Company:		Outer Dowsing Offshore Wind		Asset:		Whole Asset		
Project:		Whole Wind Farm		Sub Project/Package: Whole A		Asset		
Document Title or Description:		18	18.22 The Applicant's Change Request dated 24 October 2024					
Internal Document Number:		PP1-ODOW-DEV-CS-LET-0023		3 <sup>rd</sup> Party Doc No (If applicable):		N/A		
Rev No.	Rev No. Date		Status / Reason for Issue	Author	Checked by	Re by	viewed	Approved by
1.0 October 2024		Response to Procedural Decision within Rule 8 Letter of 17 October 2024 (PD-011)	Shepherd and Wedderburn	Outer Dowsing		ter wsing	Outer Dowsing

24 October 2024

Planning Act 2008 – Application for Development Consent GT R4 Limited, trading as Outer Dowsing Offshore Wind (the "Applicant") The Proposed Outer Dowsing Offshore Wind Farm Order **Change Request Application Reference: EN010130**

4	Appendix 4: Plan illustrating minor onshore Order Limit reductions notified in AS-025

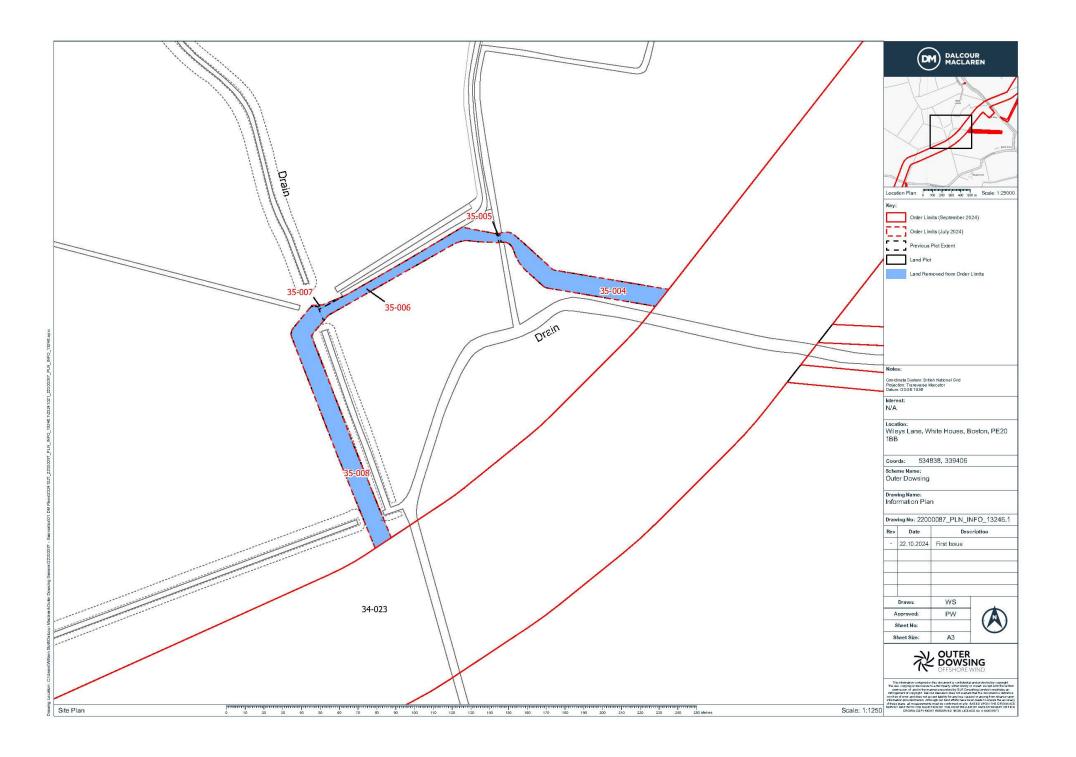
The Applicant has removed plots 35-004, 35-005, 35-006, 35-007, 35-008, 46-048 from the Order land and reduced the extent of plot 46-045 as these plots relate to accesses which have been removed at the request of the affected landowners and are therefore no longer required. Schedule 9 of the draft DCO (PD1-024) has therefore been updated to reflect this. This change therefore involves a reduction to the Order land onshore. A Plan to illustrate the reductions is set out in Appendix 4.

Changes to accesses, as shown on the plan at Appendix 4, are proposed at the request of the affected landowners following consultation with them on the proposed development. Details of that consultation is set out in the Consultation Report in Appendix 2 of this Change Application.

5	Appendix 5: Plan illustrating minor onshore Order Limit reductions referred to in AS-021

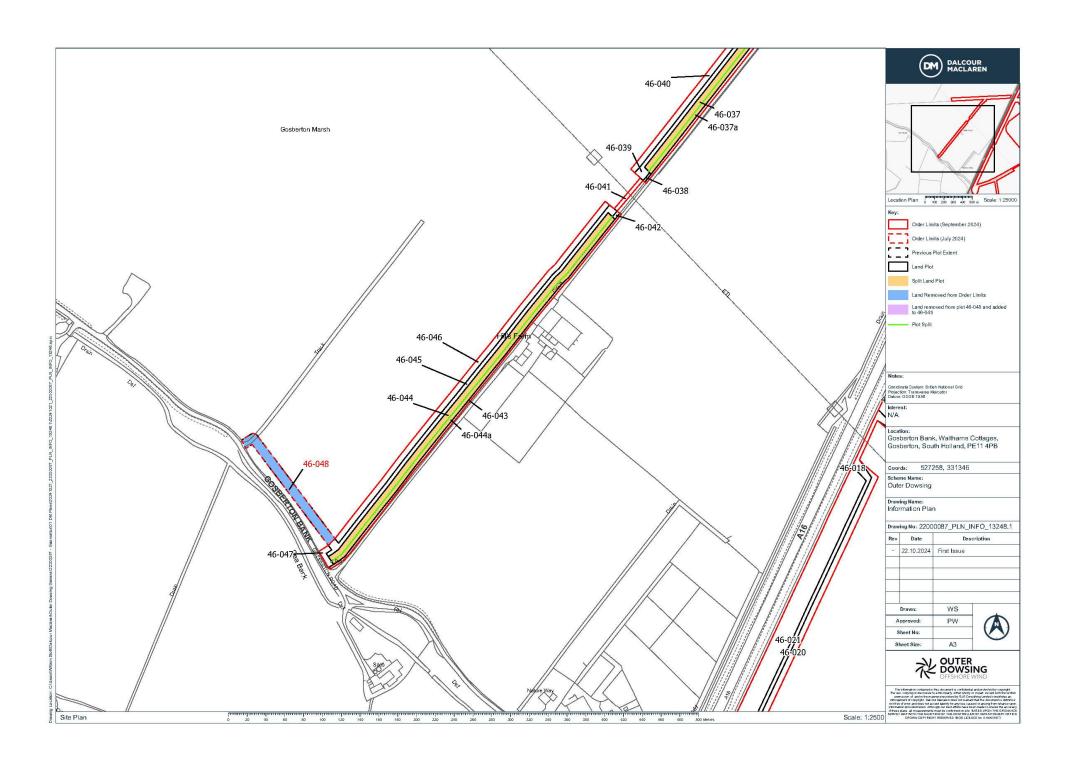
Proposed onshore Order Limit reductions were also discussed in the Applicant's Change Notification dated 29 August (AS-021) and are set out on pages 28 – 31 of the Applicant's Schedule of Changes for Plans submitted as part of its S51 Response (AS1-003). As set out there, these were Plot 36-001, 39-020, 40-004, 40-005, 43-037. A Plan– replicating pages 28 – 31 of AS1-003 – to illustrate the reductions is set out in Appendix 5.

Regarding the proposed onshore Order Limit reductions discussed in the Applicant's Change Notification dated 29 August (AS-021) (shown on the plan at Appendix 5) consultation conducted by the Applicant is also set out in the Consultation Report in Appendix 2 of this Change Application.
